Re: Initial Submission Review – Town Center at Aurora Phase 2 – Site Plan Amdt and Plat
Application Number: **DA-1105-17**
Case Numbers: **1985-6028-27**

Initial Submission Review

SUMMARY OF KEY COMMENTS FROM ALL DEPARTMENTS

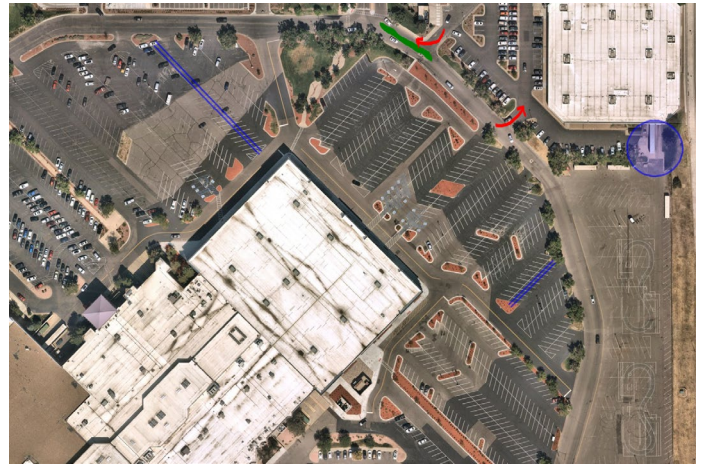
- 4A. At roundabout: It is suggested that this median be extended to prevent left turns into the Chick-Fil-a and Hobby Lobby Drive. That should be a right out only. This will avoid traffic backing up as vehicles are attempting to turn left. There are currently traffic backups associated with this driveway.
- 4B. Sidewalks should be provided on both sides of the ring road for safe pedestrian circulation. This may require closing off some of the access drives.
- 4C. There will be a lot of activity between the restaurants and the hotel. It has been discussed that this area may be used as a plaza for special events. Please eliminate the first rows of parking adjacent to the building to allow for a more flexible use of the space and to limit the amount of vehicles circulating through the area to minimize pedestrian/vehicle conflicts. Please see highlighted area where plaza should be extended.
